MODIFICATIONS FOR EASIER CHIN ASSEMBLY

SHELL MOLD MODIFICATION

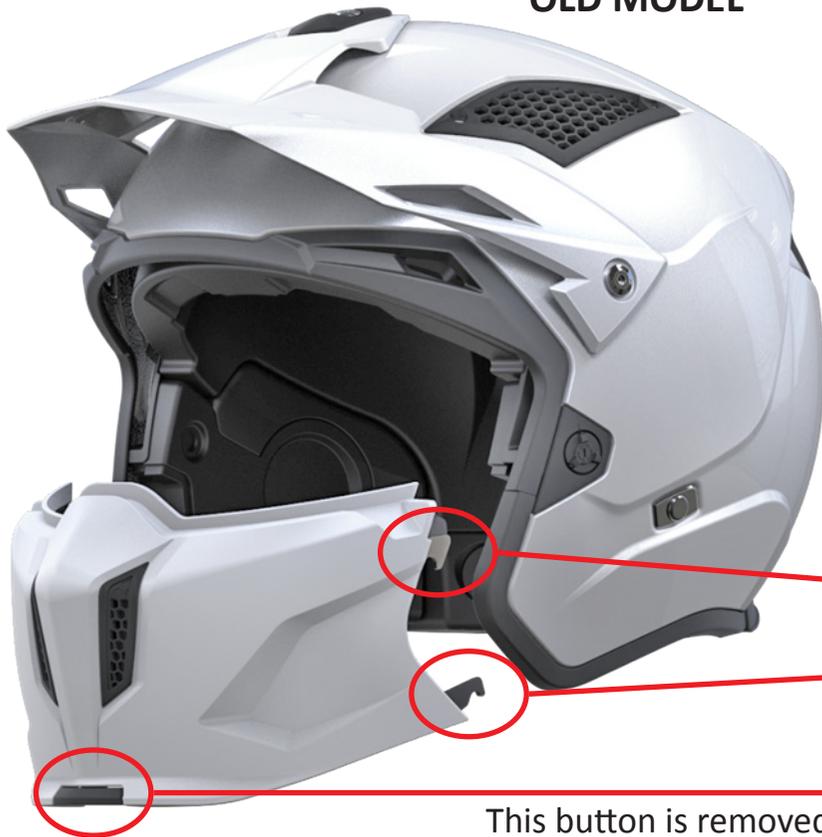
OLD MODEL

Hooks are replaced for this

This button is removed

NEW MODEL
